T.E.D.S. Exception for the Site Plan of Van Gundy's Recycle Center/Salvage Yard

Prepared by: Robert W. Jones II, P.E.
Vortex Engineering, Inc.
255 Vista Valley Drive
Fruita, CO 81521
970-245-9051
VEI # F06-026

Re: Design Exception #DE6-13, 14, 15, 16 – Van Gundy's Proposed site on 4th Ave.

DESIGN EXCEPTION #DE 6-13, 14,15 & 16

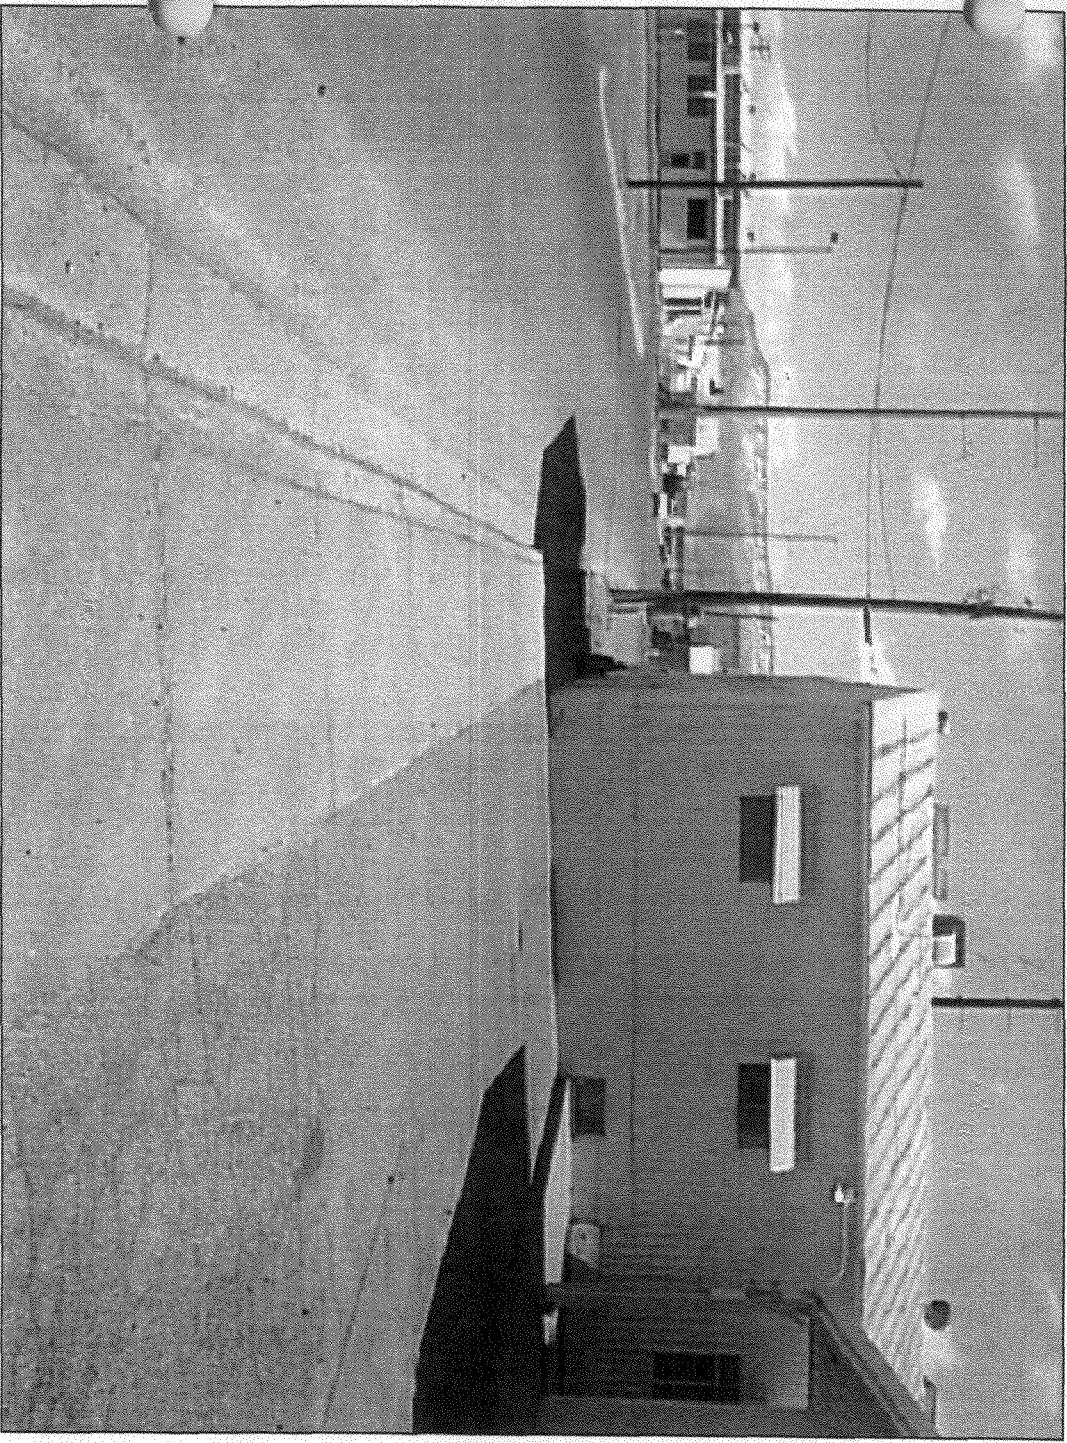
The Site Plan submitted to Community Development does not meet the TEDS standards in regards to providing a 14 Foot Multi Purpose Easement as shown on an Industrial Street Section (attached). As mentioned earlier, this site is approximately 20 percent smaller than the previous site and has more site constraints with the existing buildings and the triangular shape of the new lot. Quite simply, Van Gundy's needs as much room on the site for storage as possible. Additionally, the building in the northeast corner of the Sterling Site is approximately 6 foot from the existing street curb or 1 foot from the property line. A photo is attached as Exhibit A.

LOOKING EAST - EXISTING BUILDING
APPROXIMATELY 6' FROM BACK OF CURB

TITLE: EXHIBIT "B"

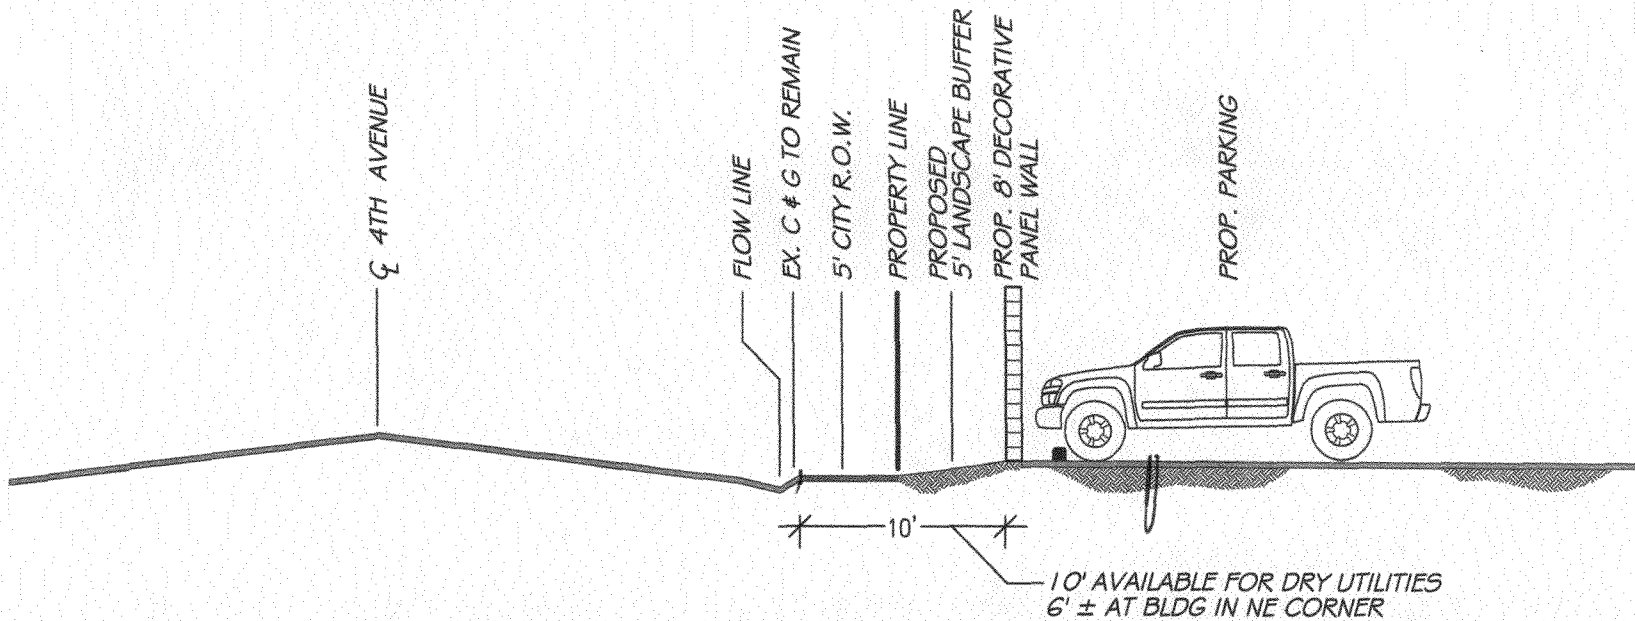
As part of the Conditional Use Permit (CUP), the City has required installation of an 8-foot high screening wall along 4th Avenue and 50 feet along each side from 4th avenue. Van Gundy's proposes to place the screening wall 5 feet from the property line to allow for additional storage and parking. Currently there is approximately 5 feet behind the existing curb to the property line. With the proposed wall placed 5 feet from the property line, this allows a total of 10 feet behind the curb for utilities. The exception to this is the location of the existing building in the northeast corner of the site. As discussed earlier, this building is approximately 6 feet from the street curb and the width is approximately 50 feet wide. Utilities would need to be placed in the 6-foot section between the building and the street curb. A sketch is attached as Exhibit B.

- Reduce to 14-foot multipurpose easement along 4th Avenue to 5 feet
- Eliminate the 14 foot multi purpose easement along 4th Avenue in front of the existing building (This would be for approximately 50 feet and utilities can be placed in the 6 foot section between the building and street curb)

- DE #13. Vortex Engineering requests the revision of Page ST-07, TEDS Chapter 5, to allow a five foot wide Multi-Purpose easement in lieu of the standard 14' easement. The Utility Coordinating Committee has reviewed this request and has provided a letter of support for this request.
- DE # 14. Vortex Engineering requests TEDS standard 4.2.5.1 be revised to allow 30' of storage between the new scale Van Gundy will install south of the main entrance off 4th Street and the flowline in the adjacent roadway.
- DE # 15. Vortex Engineering requests TEDS standard 4.1 be revised to allow driveways into the site to be offset less than the required 50' from driveways on the opposite side of the street.
- DE # 16. Vortex Engineering requests TEDS standard 4.3.1 be revised to allow 4th Ave. to function as a circulatory roadway between the scale and the storage yard.

- DE#13 – Approved
- DE#14 – Denied
- DE#15 – Approved

TITLE: EASEMENT REDUCTION EXHIBIT	SCALE: N.T.S.	DATE: 05/08/06	DRAWN BY: KDF CK'D BY: RWJII	CAD I.D.#: Gundy-Site.dwg PROJECT#: F06-026
--------------------------------------	------------------	-------------------	---------------------------------	--

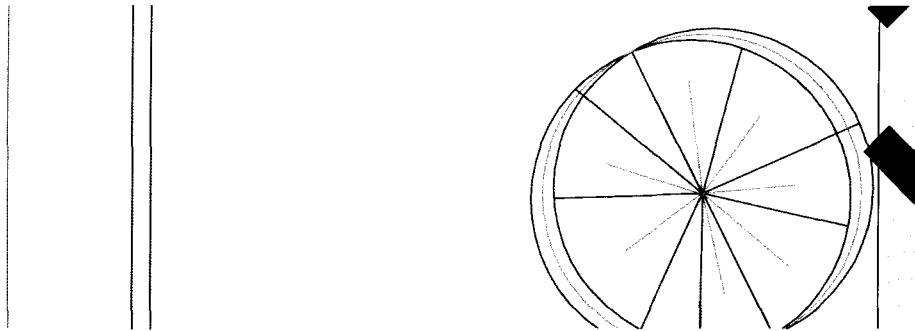
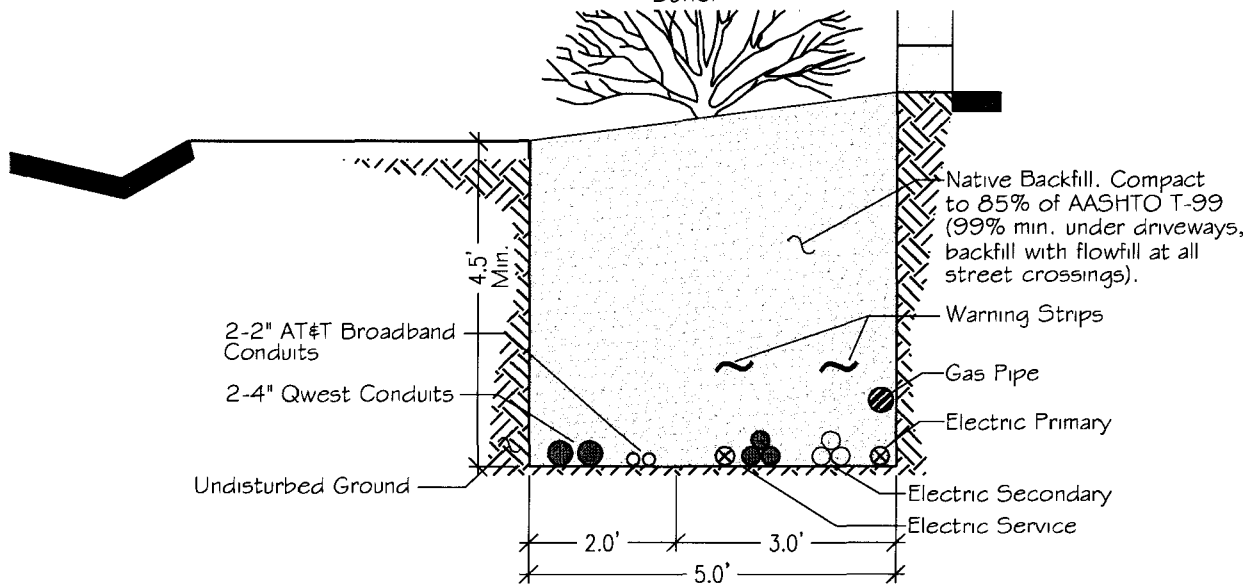
We understand that this easement is for “dry utilities”, Electrical, Cable, and Telephone. Including the area behind the curb, there will be approximately 10 feet for utilities. A sketch is included in Exhibit C. The 50-foot section in front of the building in the northeast corner of the site will have approximately 6 feet for “dry utilities”. We have checked with Xcel Energy, Bresnan Communications, and Qwest about this restriction. Bresnan has indicated approval (included in Exhibit C). We are awaiting comments from Xcel and Qwest.

CITY OF GRAND JUNCTION FILE PRESENTED BY ROBERT JONES WITH VORTEX ENGINEERING FOR AN EASEMENT WIDTH REDUCTION ALONG 4TH AVE. HAS BEEN REVIEWED AND APPROVED BY THE UTILITY COORDINATING COMMITTEE.
